# Assessment of Dam Safety Coal Combustion Surface Impoundments (Task 3) Draft Report

**Kentucky Utilities**

**Ghent Generating Station**

December 8, 2009

IMAGE REFERENCE: ATB #2 STABILITY ANALYSIS BY CHA, SEISMIC CONDITION- DOWNSTREAM SLOPE.

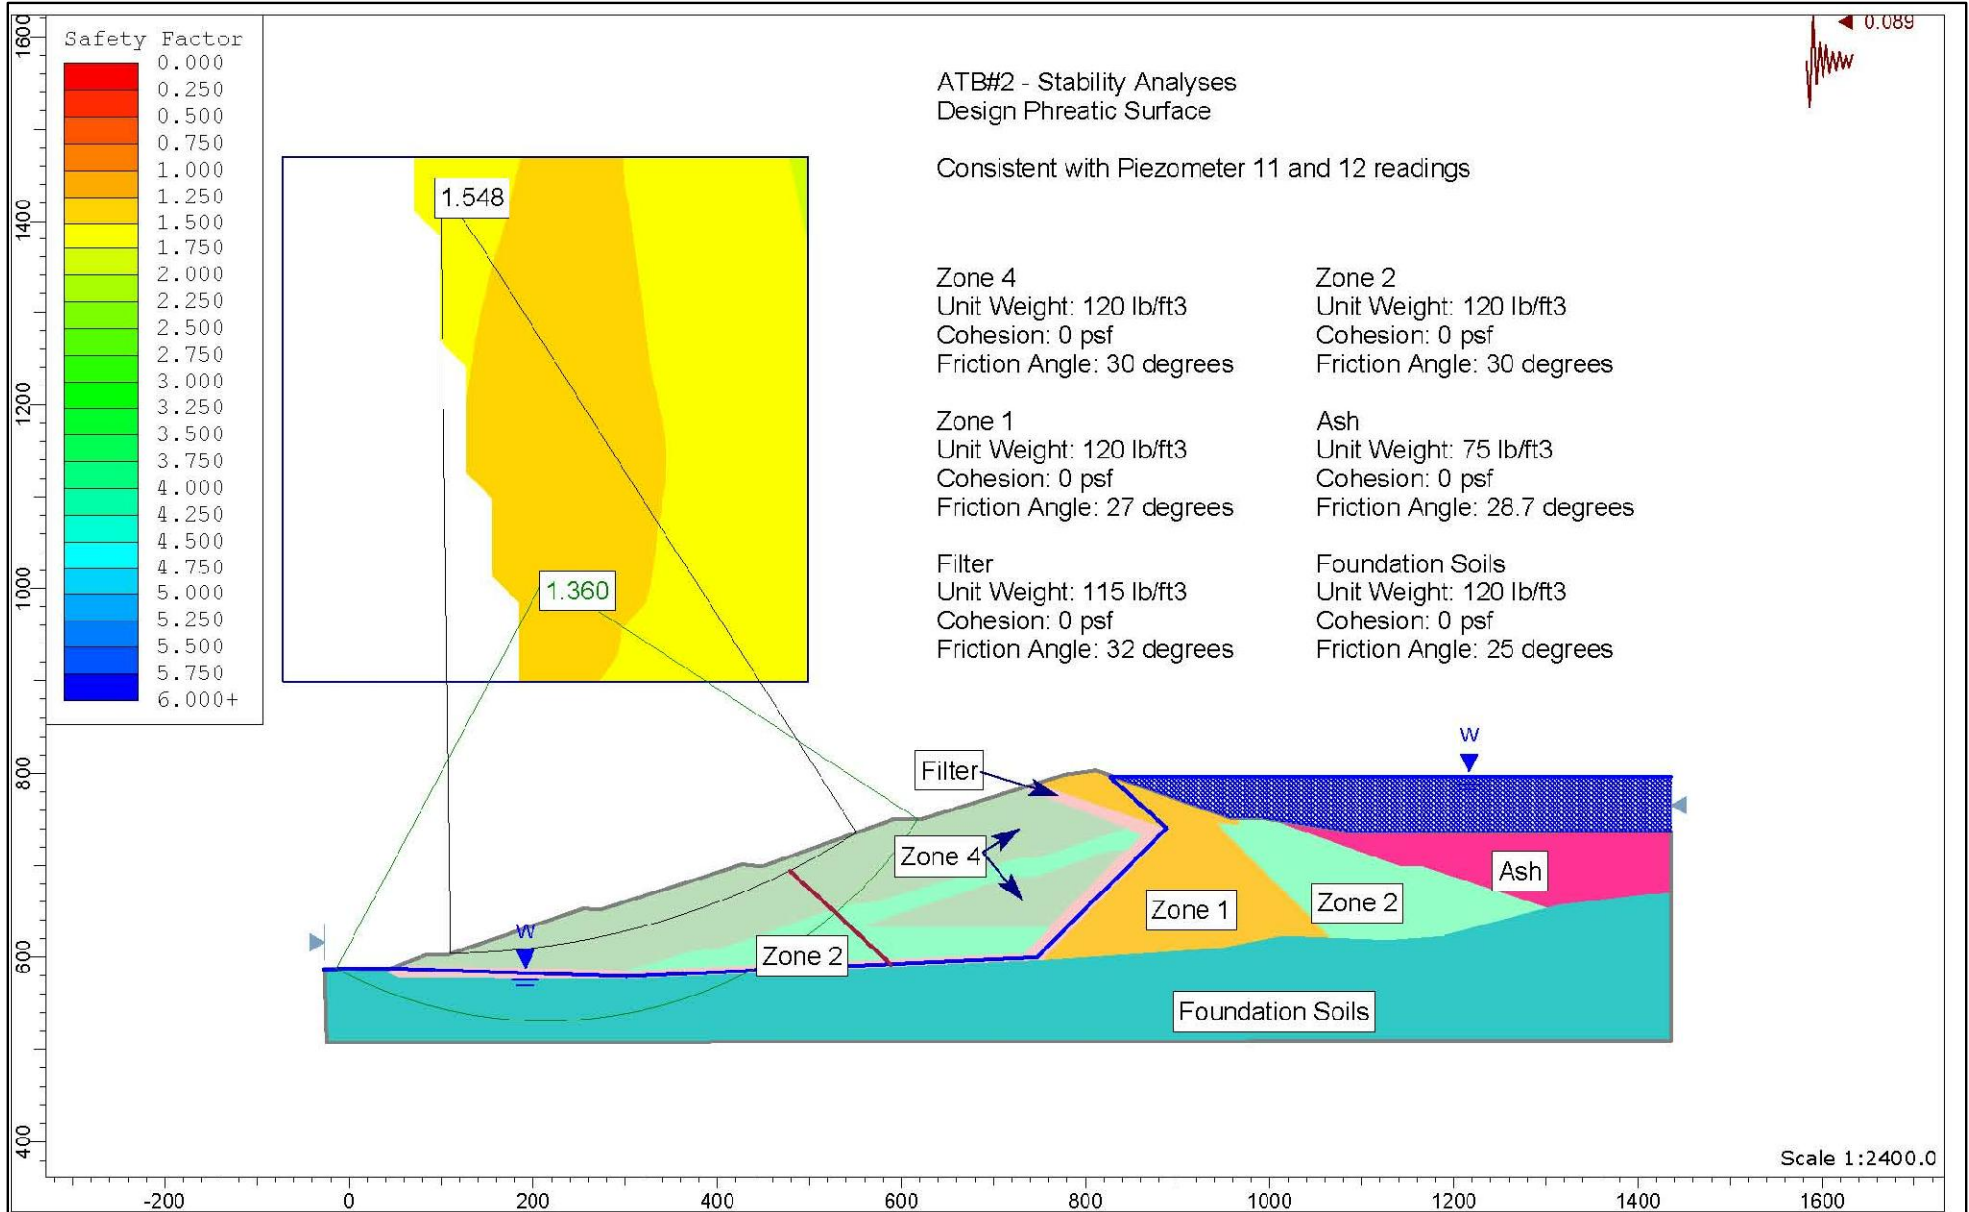
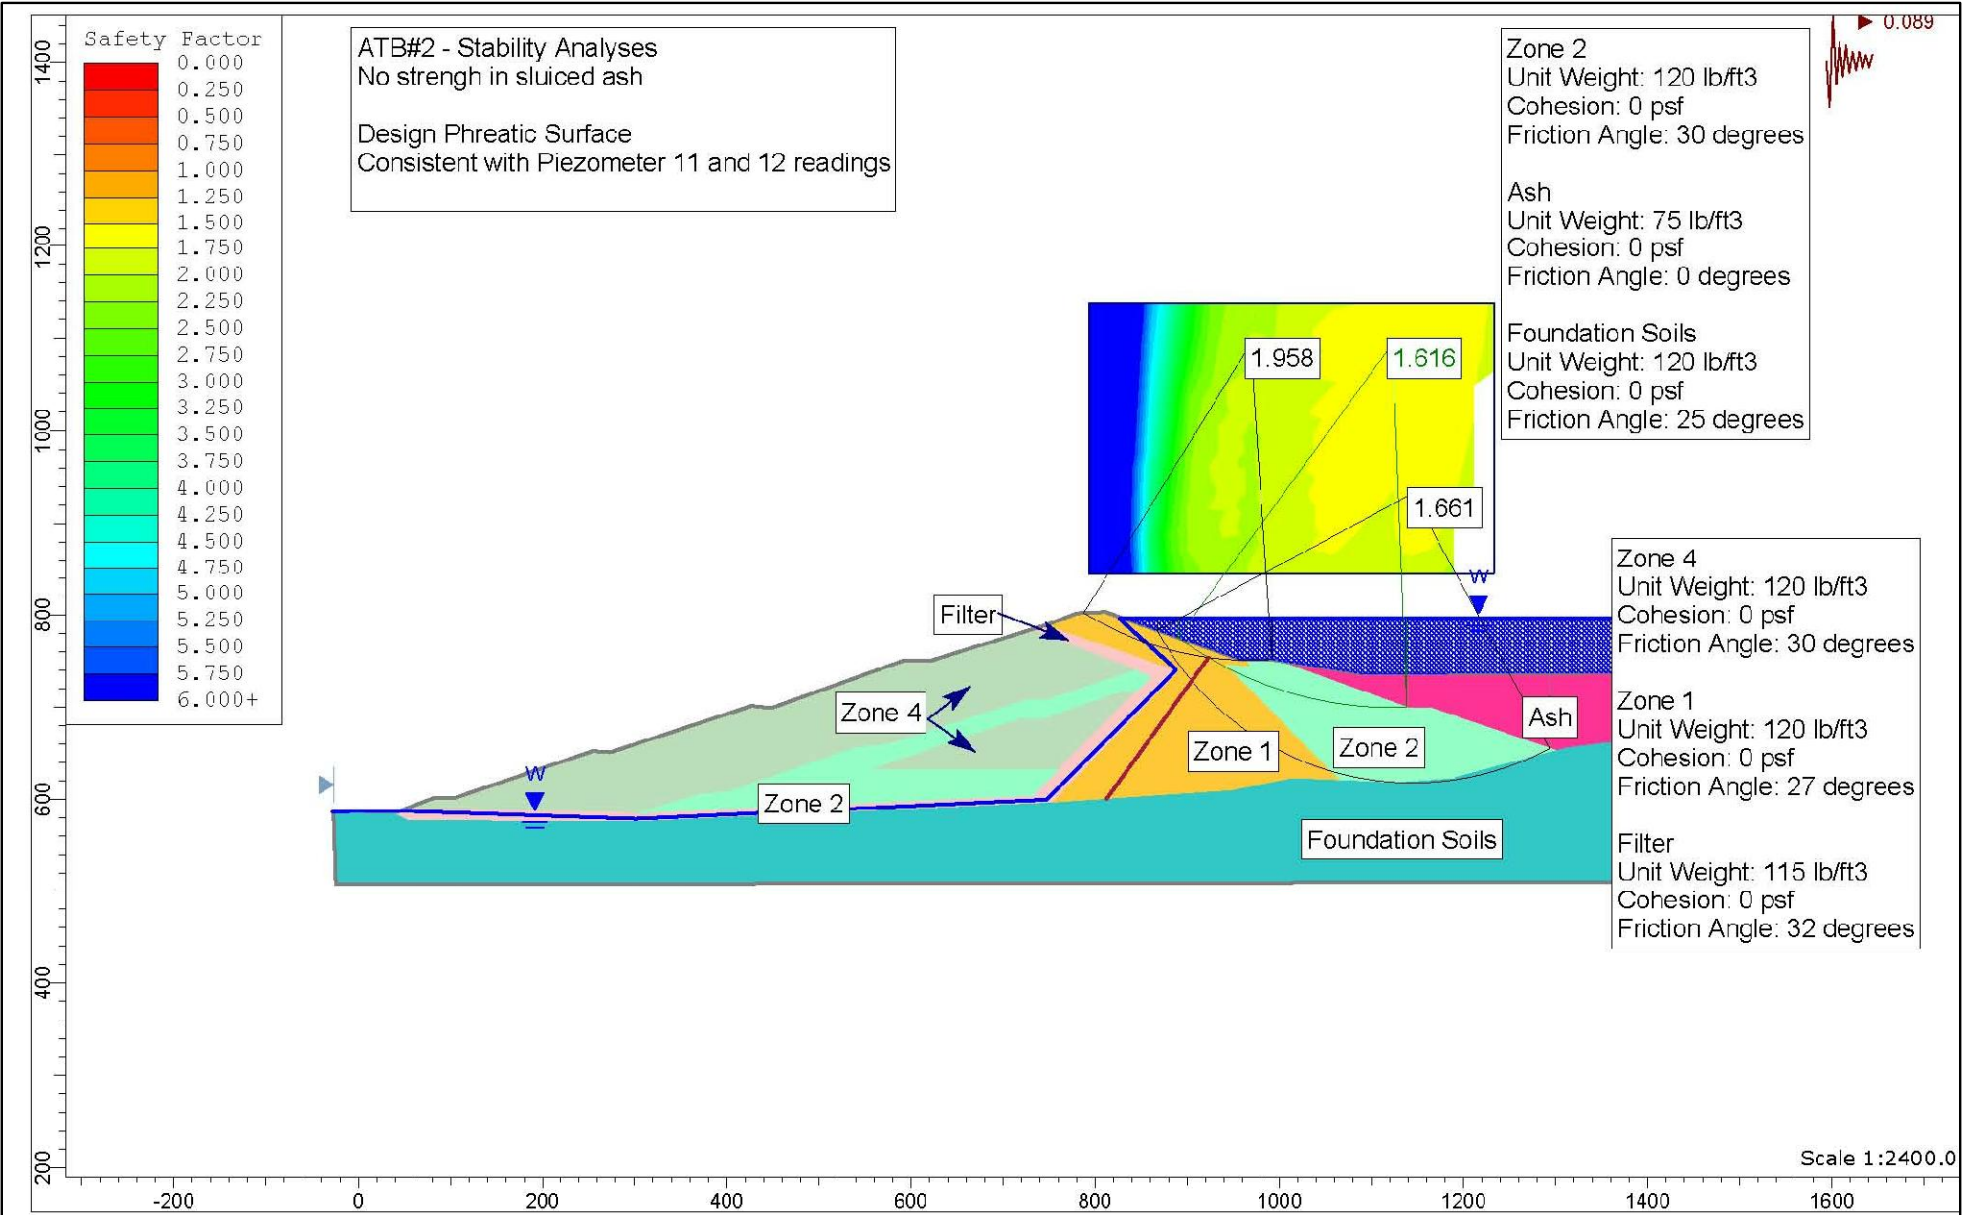
CHA recreated the maximum height cross section used in FMSM’s analyses using the computer program Slide™ and the soil properties from Table 8 above to confirm these results. CHA performed these analyses to verify the calculated minimum factors of safety because the record drawings showed very shallow surfaces representative of a surface slough rather than a deep seated failure as the worst case scenario, whereas FMSM had reported deep seated failure conditions in the design report. These shallow surfaces are sometimes an anomaly of the computer programs used for the analysis and verification of factors of safety against deep seated slip surfaces is warranted.
